ENGINE - STAGE 9 TO 12 DISK ASSEMBLY - INCREASED LIFE DISK ASSEMBLY - CATEGORY CODE 6
- MOD.ENG-72-0069

V2500-ENG-72-0069

SERVICE BULLETIN

Location of Stage 9 to 12 HP Compressor Disk Assembly
Fig.1

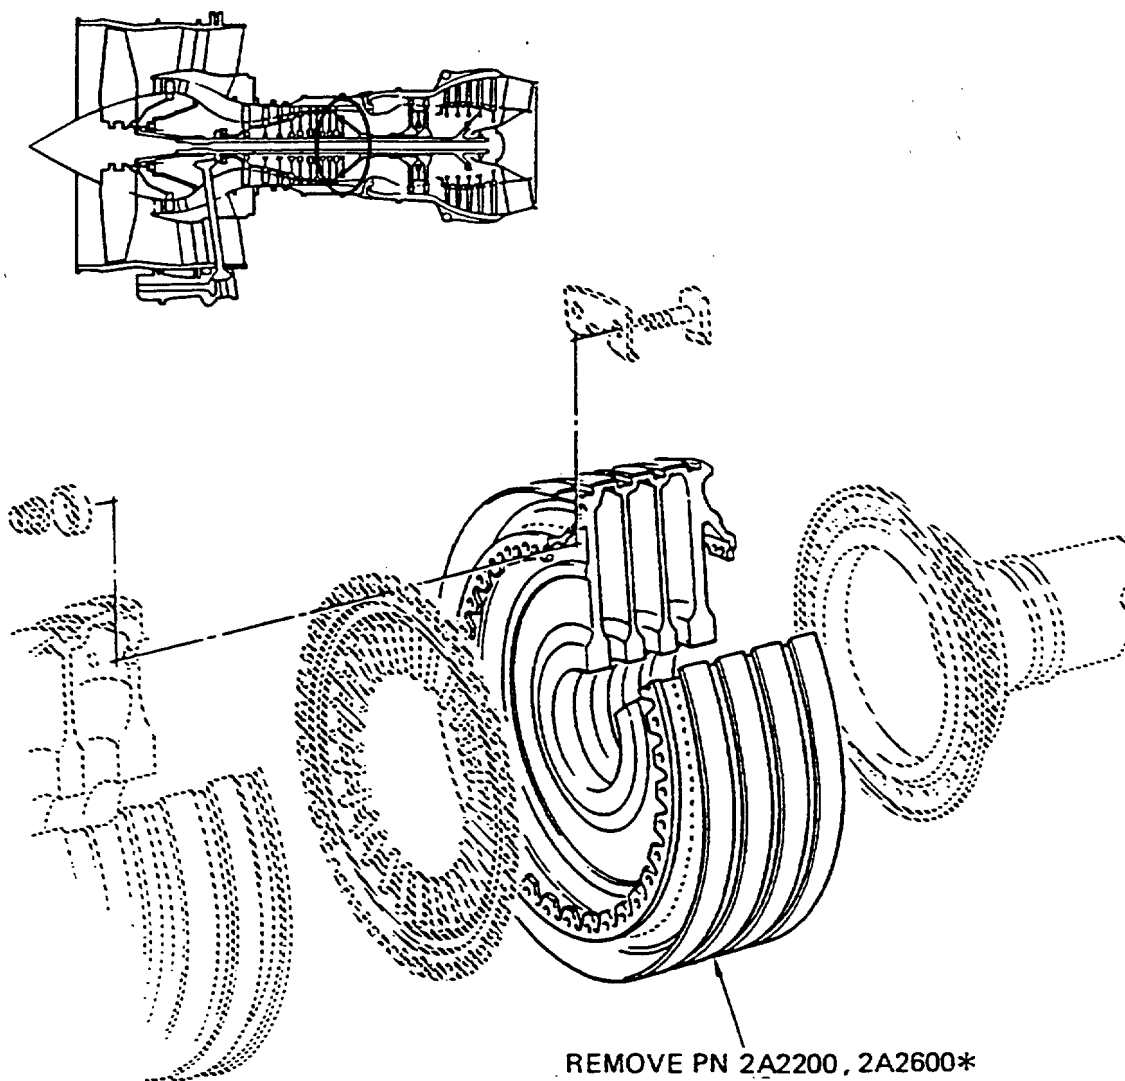
REMOVE PN 2A2200, 2A2600*
OR 2A2100, STAGE 9 TO 12 DISK
ASSEMBLY, DO A MODIFICATION, AND INSTALL
AS PN 2A3300, 2A3500 AND 2A3400
STAGE 9 TO 12 DISK ASSEMBLY (1 off)
RESPECTIVELY

Modification of Stage 9 to 12 Disk Assembly (Datum Locations)
Fig.2 (Sheet 1 of 6)

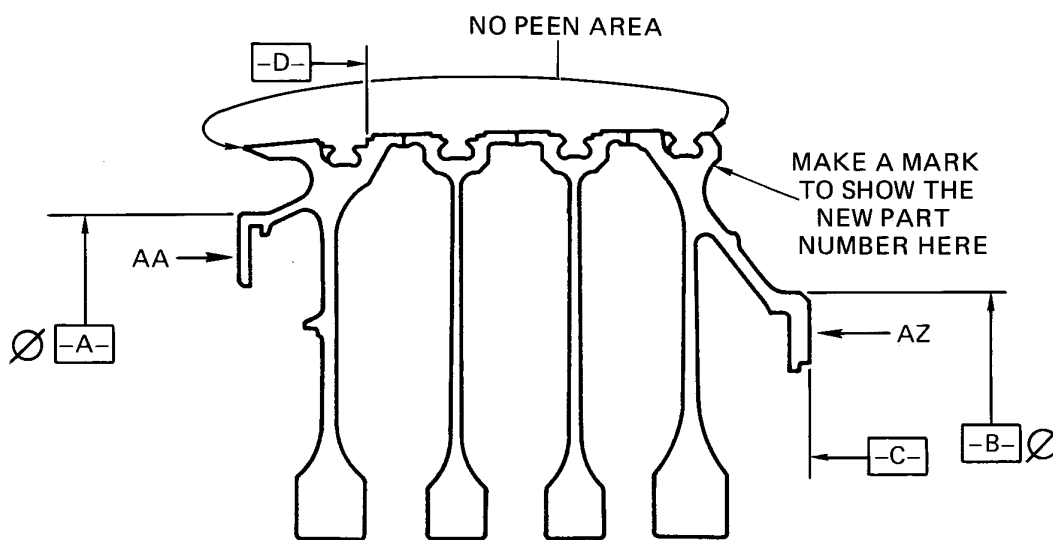
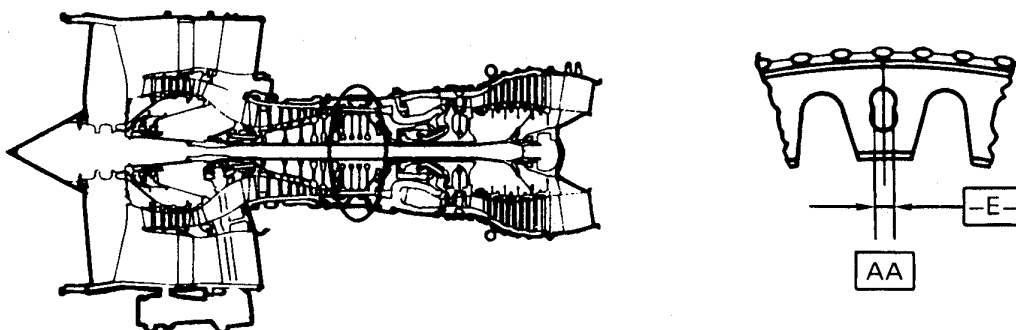
| <p>(b) Set-up and machine to 20 slots (location as specified) on the inner flange at the stage 12 disk location</p> | <p>Refer to Figure 2, Sheets 1 and 2, requirements</p> |

Modification of Stage 9 to 12 Disk Assembly (Machine the Stage 12 Disk Scallop)
Fig.2 (Sheet 2 of 6)

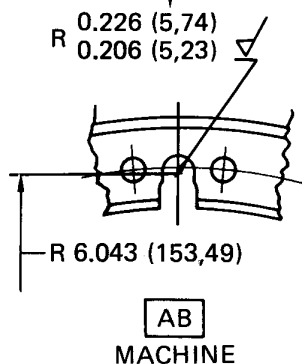
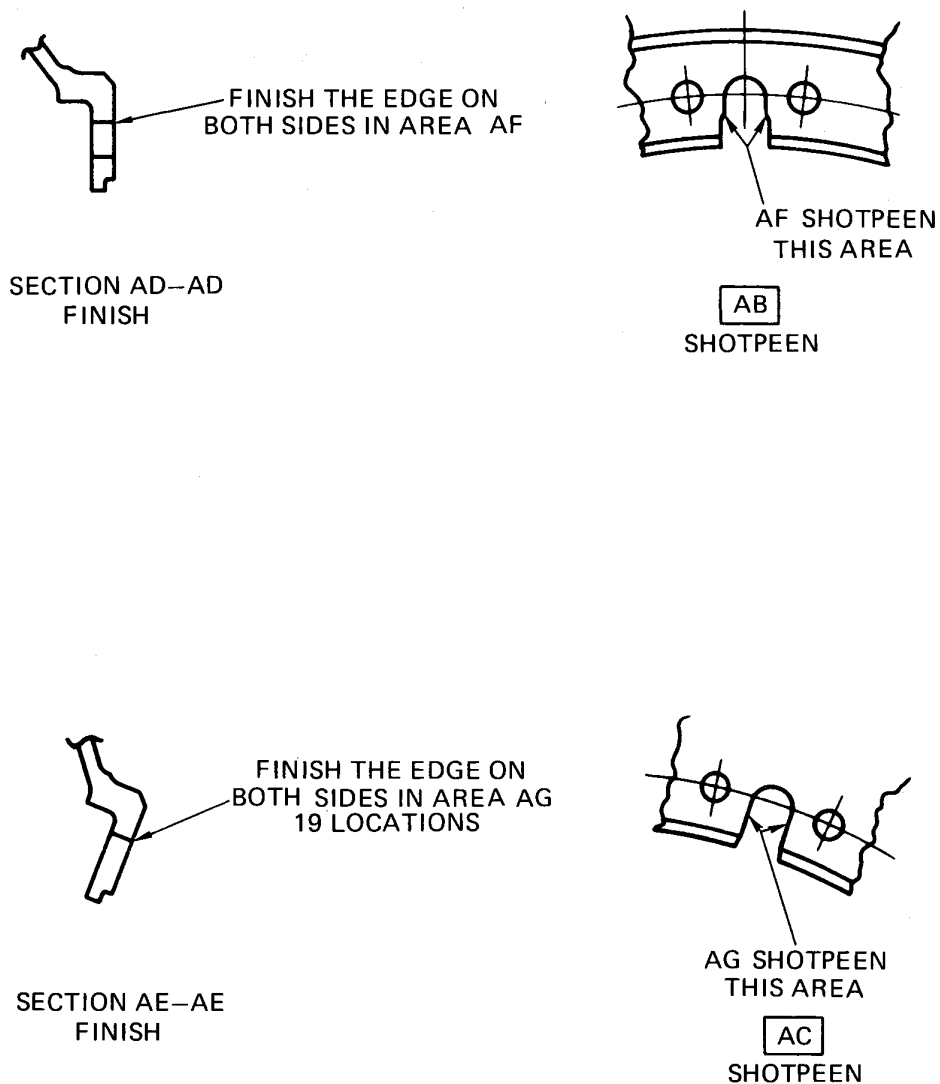
1 SLOT AT LOCATION AB

19 SLOTS LOCATION FOUND BY
20 SLOTS EQUALLY SPACED AND NOT
TO INCLUDE 1 SLOT AT AB

THESE SURFACES FROM
FIRST SLOT ARE PERMITTED
AFTER MODIFICATION

Modification of Stage 9 to 12 Disk Assembly (Shot Peen the Stage 12 Disk Scallop)
Fig.2 (Sheet 3 of 6)

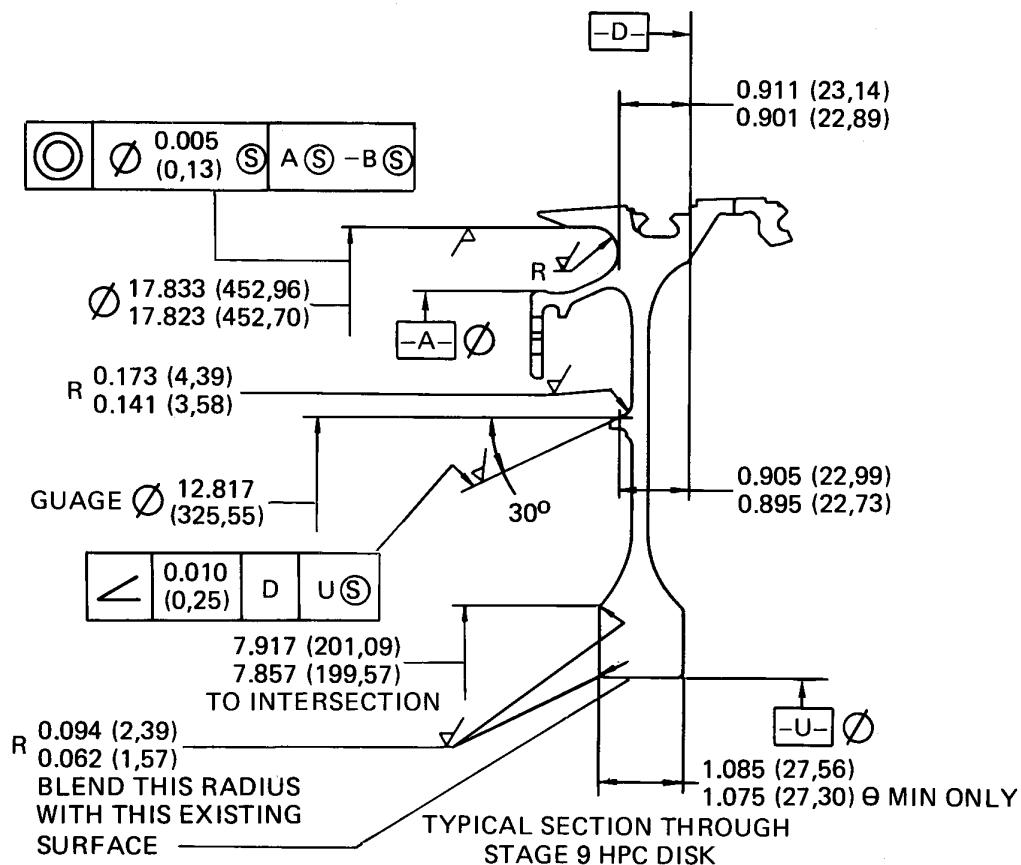
| <p>(c) Abrasive finish the edge of the slots at the locations indicated by the specification given</p> | <p>Refer to Figure 2, Sheets 1 and 3, requirements. Refer to Reference (3) Control No./TASK No.70-35-19-350-501</p> |
| <p>(e) Shot peen the area indicated by the procedure specified to an intensity of 6A. Use SAE 170 Maximum Cast Steel Shot with a hardness of 45 - 55 HRC or equivalent</p> | <p>Refer to Figure 2, Sheets 1, 3 and 6, requirements. Refer to Reference (3) Control No./TASK No.70-38-13-380-501</p> |

Modification of Stage 9 to 12 HP Compressor Disk Assembly (Machine the Stage 9 Disk)
Fig.2 (Sheet 5 of 6)

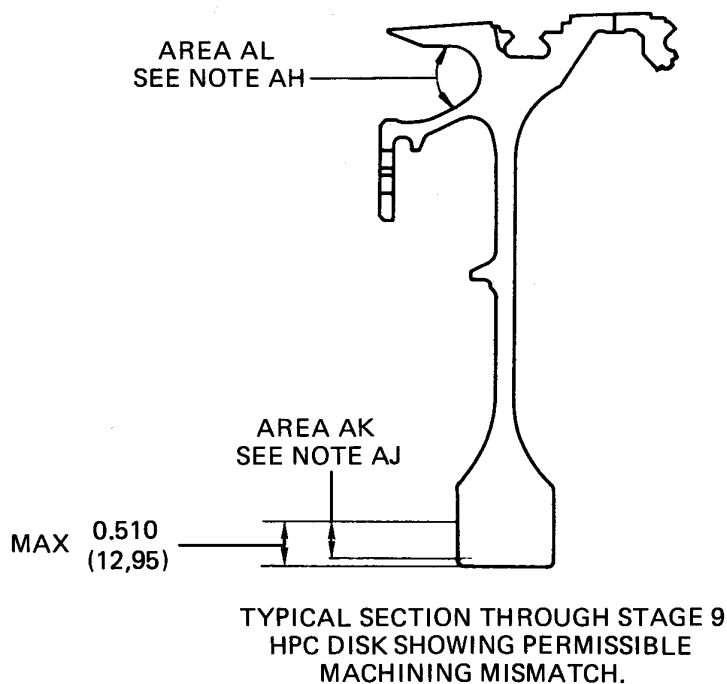
| <p>(d) Set-up and machine the stage 9 disk locations to the dimensions specified</p> | <p>Refer to Figure 2, Sheets 1, 4 and 5, requirements</p> |

NOTE AH:
0.001 (0,03) MAX MISMATCH PERMISSIBLE IN AREA AL.
USE 0.094 (2,39) MIN FILLET RUNOUT RADIUS.
MISMATCH MUST NOT OCCUR AT TANGENCY OF FILLET TO FLAT.

NOTE AJ:
0.010 (0,25) MAX MISMATCH PERMISSIBLE IN AREA AK.
USE 0.234–0.266 (5,94–6,76) FILLET RUNOUT RADIUS.
MISMATCH MUST NOT INTERRUPT ADJACENT RADIUS.

Modification of Stage 9 to 12 HP Compressor Disk Assembly (Shot Peen the Stage 9 Disk)
Fig.2 (Sheet 6 of 6)

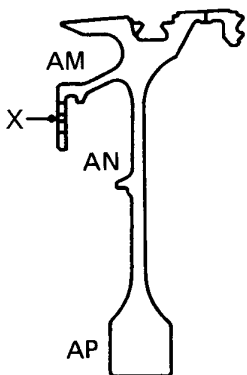
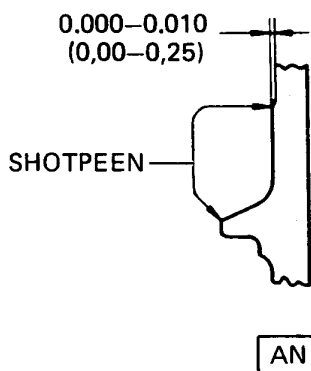
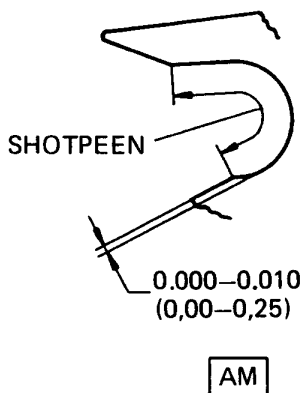
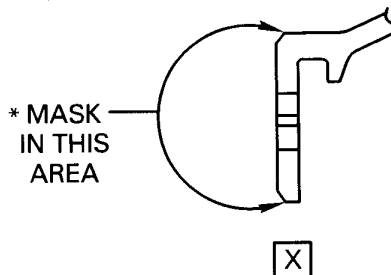
* NOTE : NO OVERSPRAY IS PERMITTED IN THIS AREA. YOU CAN MASK THIS AREA.
OVERSPRAY IS PERMITTED IN ALL OTHER OPTIONAL AREAS. YOU CANNOT
MASK IN ALL OTHER OPTIONAL AREAS

Modification of Stage 9 to 12 Disk Assembly (Balance the Stage 9 to 12 Disk Assembly)
Fig.3

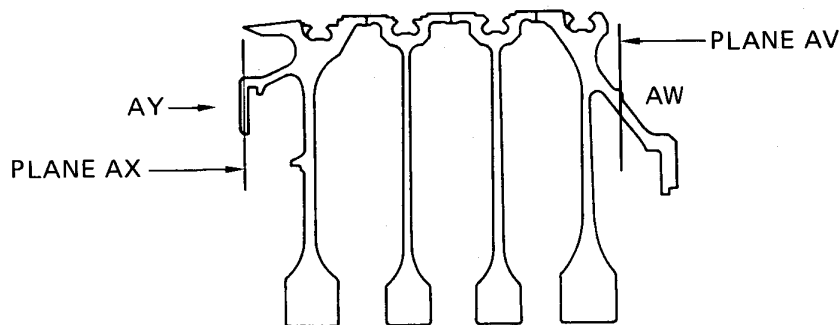
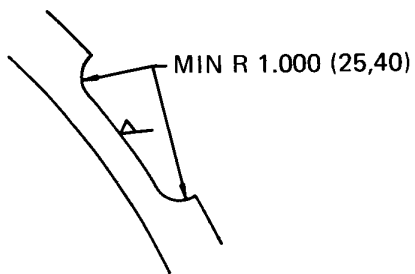
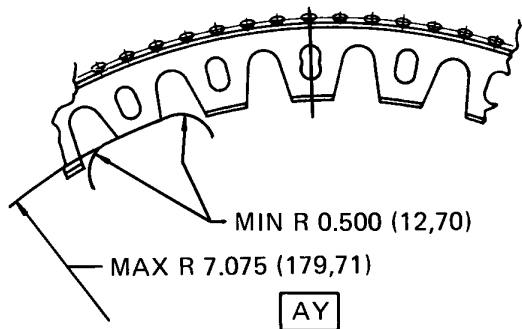
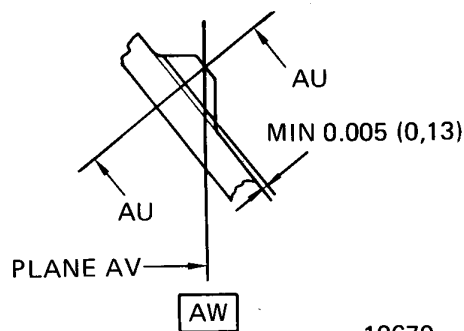
| <p>(f) Do a balance check on the disk assembly as follows:</p> | <p>Refer to Figure 3. Refer to Paragraph H. for the necessary tools to do the balance check</p> |

-
- 1 Mount the Disk Assembly on Diameters A and B
 - 2 Rotate the Disk Assembly at 900 rpm
 - 3 Make sure that the dynamic unbalance measured in Plane AX is not more than 0.50 oz.in. (360 g.mm)

- 4 Make sure that the dynamic unbalance measured in Plane AV is not more than 0.50 oz.in. (360 g.mm)

- (g) Correct any unbalance that is not in the limit by removal of material
